Subject Fw: WIR Citation: Tank 30 Demister

I have been asked to provide Citation guidance on the removal of the Tank 30 purge ventilation demister and am requesting your concurrence.

Figure 7 Type III Tank Purge Ventilation System

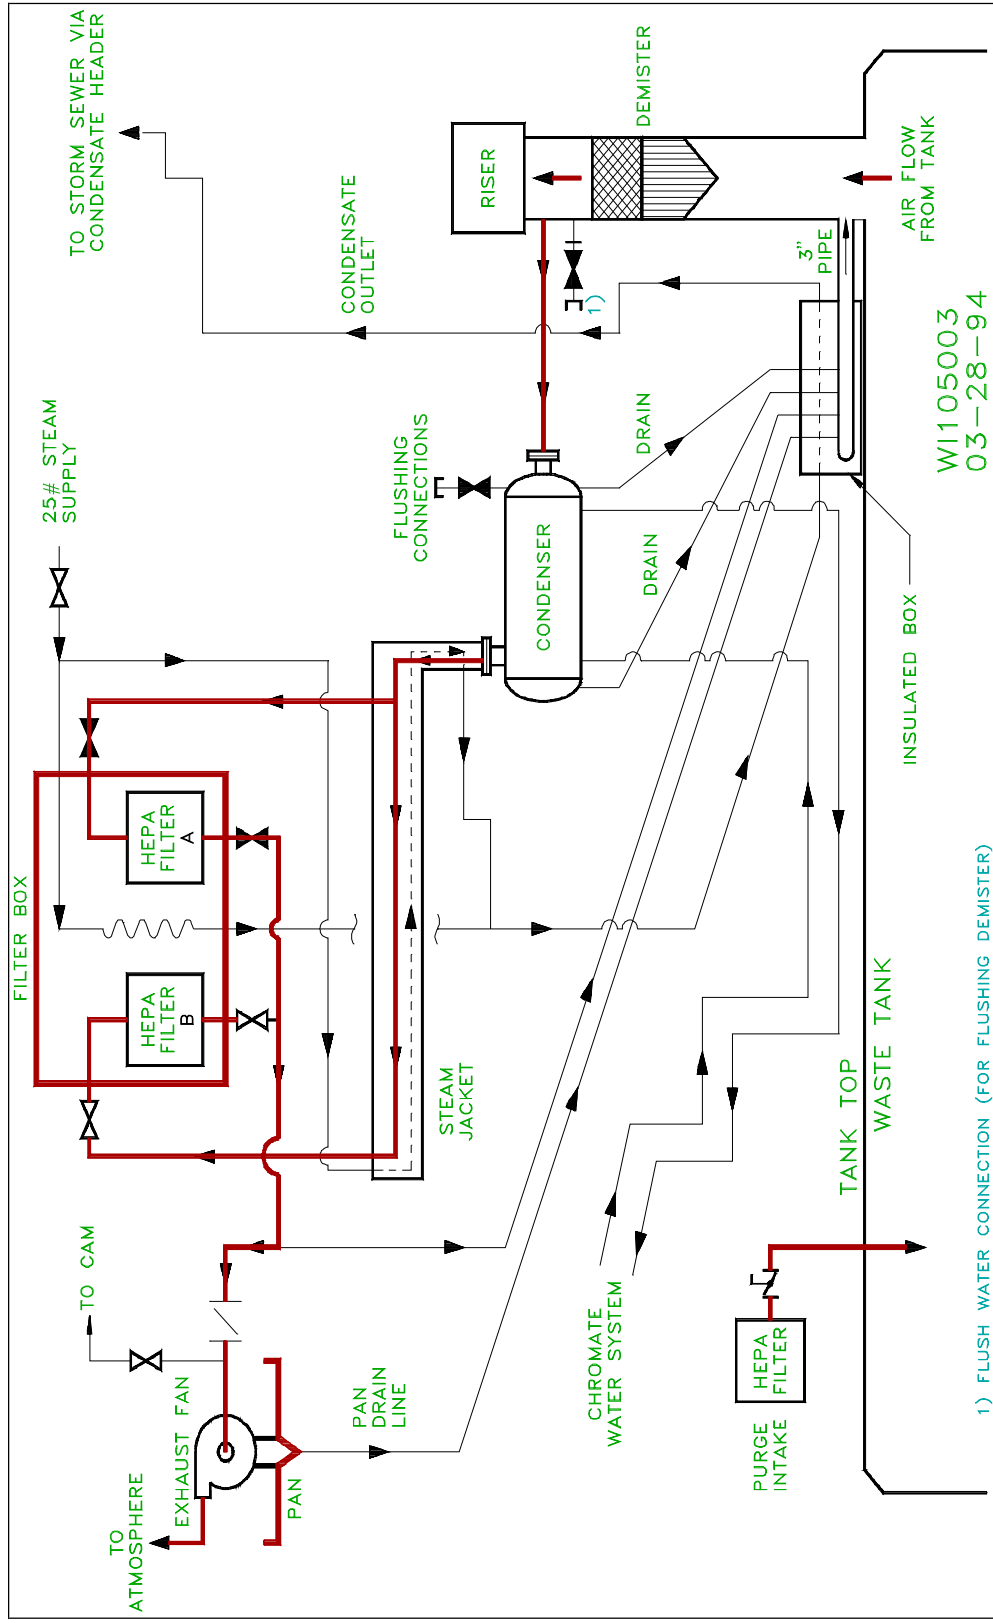
Can we put together a sketch or drawing that shows how the [ventilation system components](#) fit together and the location? Howard will be able to look at this on Thursday as I understand it, so if you were able to get a drawing to him by then we may be good to go.

I have reviewed your e-mail and I think you are ok in your determination. However - there is always a however. However, I would like to see some drawings that show the demister in a ventilation system. I get nervous when you call it a Tank demister.

Until I can round up a drawing of a Type III tank configuration, I printed this figure showing the components from a Tank Farm operator training manual. Please note that it is not to scale.
